MILITARY SPECIFICATION SHEET

BEARINGS, SLEEVE, PLAIN SELF-LUBRICATING, 325°F

This amendment forms a part of MIL-B-81934/1C, dated 25 September 1987 and is approved for use by all Departments and Agencies of the Department of Defense.

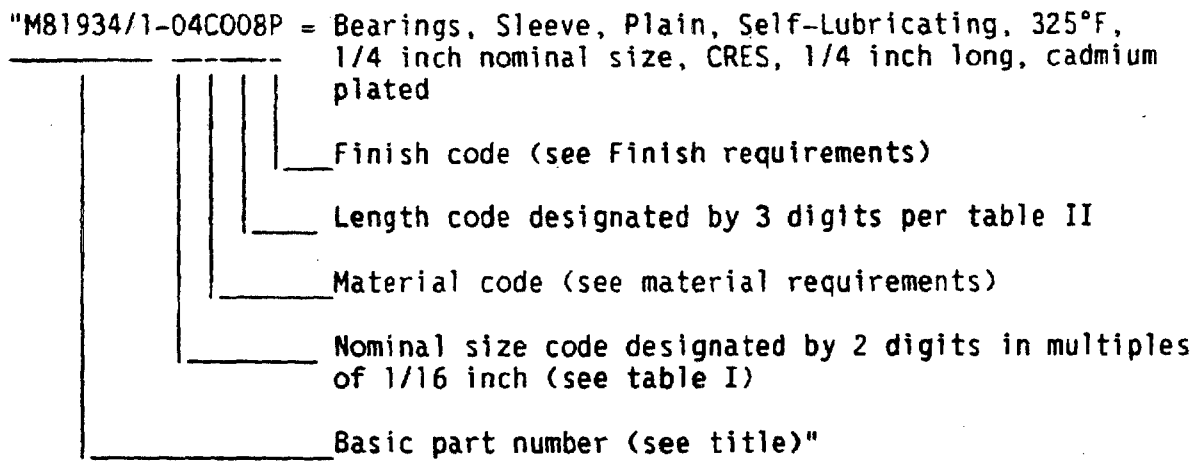
Under the heading "Example of part number," delete and substitute the following:
